Rezoning Transportation Analysis

Petition Number: 2025-086

General Location Identifier: 10817111

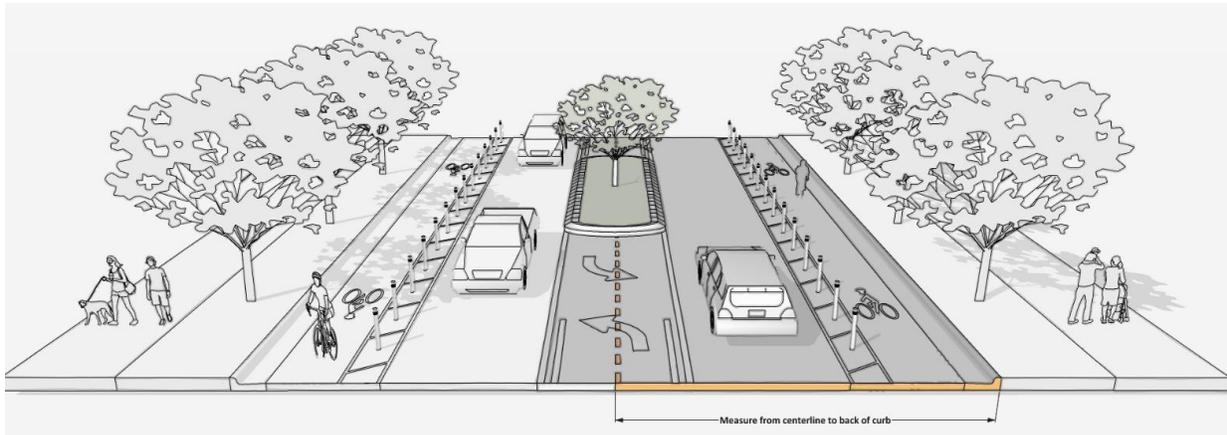
Label and dimension the curb and gutter from the centerline for each road on the site plan.

~~Clarifying comment 09-24-25: Revise site plan by placing 27-foot dimension towards your site and add a callout stating that is the proposed back of curb. Show curb and gutter being placed along sites frontage.~~

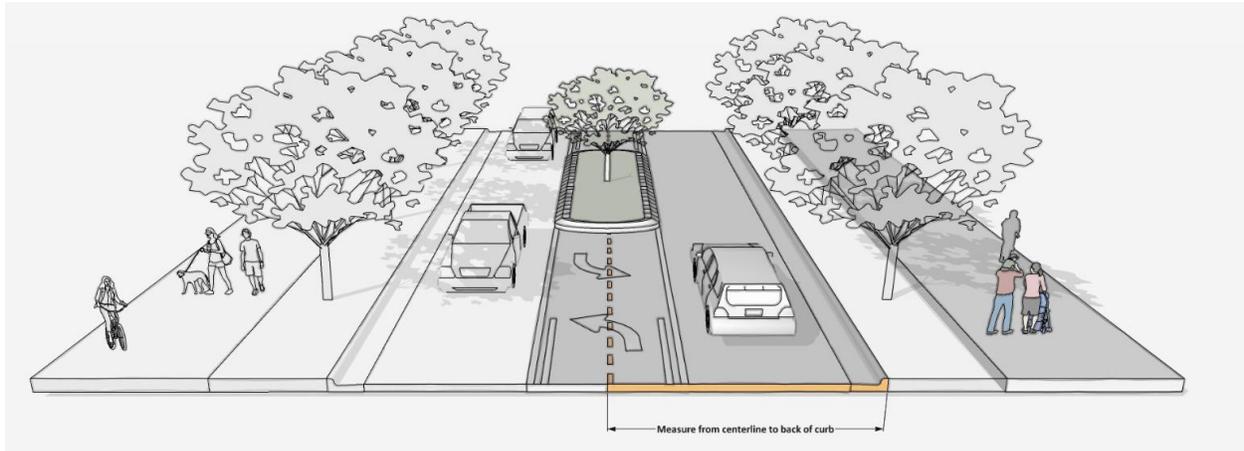
Clarifying comment 09-24-25: Revise site plan and conditional note(s) by showing a 5-foot bike lane and 3-foot buffer. Callout striping on the site plan and revise condition note(s) to commit to installing the bike lane per Charlotte Streets Map. Currently the 27-foot dimension is towards the opposite side of the road.

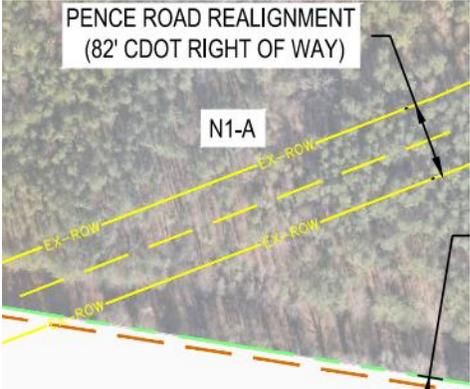
Clarifying comment 01-21-25: Line type on site plan shows “EX-ROW”. Revise line type to clearly show the right-of-way is not existing but is to be reserved for the future street.
